# Access Compliance Report

## Public Rights-of-Way

Intersection ID: 10205	Main Street: STATESVILLE_AV	Cross Street: OAKLAWN_AV	Location: SW
ADA ID: 979C3891C8C2	Ramp Type: Perp	Initial Pass/Fail: Fail	Overall Compliance: No
		Severity Score: 10

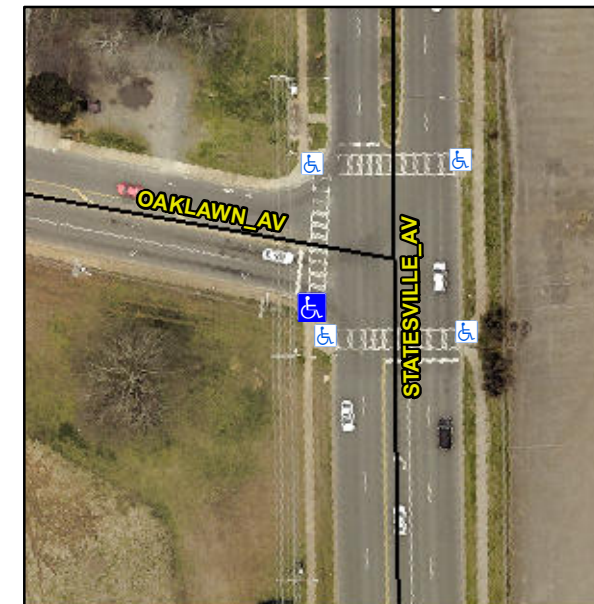
**Not Found, R304.5.1**

Compliance	Description	Data	Compliance	Description	Data
N/A	Ramp Length (in)	49.0	Yes	Ramp Slope (%)	7.3
No	Ramp Width (in)	47.5	Yes	Ramp XSlope (%)	3.2
N/A	Flare Type LT	N/A	N/A	Flare Type RT	N/A
N/A	Flare Slope LT (%)	N/A	N/A	Flare Slope RT (%)	N/A
N/A	Flare Traversable LT?	N/A	N/A	Flare Traversable RT?	N/A
N/A	Landing Length (in)	N/A	N/A	DWS Provided?	N/A
N/A	Landing Width (in)	N/A	N/A	DWS Contrast?	N/A
N/A	Landing Slope (%)	N/A	N/A	DWS Length (in)	N/A
N/A	Landing X Slope (%)	N/A	N/A	DWS Full Width?	N/A
N/A	Landing Curb? (Y/N)	N/A	N/A	DWS Offset (in)	N/A
N/A	Shared Landing?	N/A			
N/A	Gutter Ponding?	N/A	N/A	Gutter Slope (%)	N/A
N/A	Gutter Lip Ht (in)	N/A	N/A	Gutter X Slope (%)	N/A
N/A	Painted X Walk1?	Yes	N/A	Painted X Walk2?	N/A
	X Walk 1 Direction	To N		X Walk 2 Direction	N/A
N/A	X Walk 1 Width (in)	90.5	N/A	X Walk 2 Width (in)	N/A
	X Walk 1 Slope (%)	0.9		X Walk 2 Slope (%)	N/A
	X Walk 1 X Slope (%)	3.2		X Walk 2 X Slope (%)	N/A

**Remove & Replace Entire Ramp.**
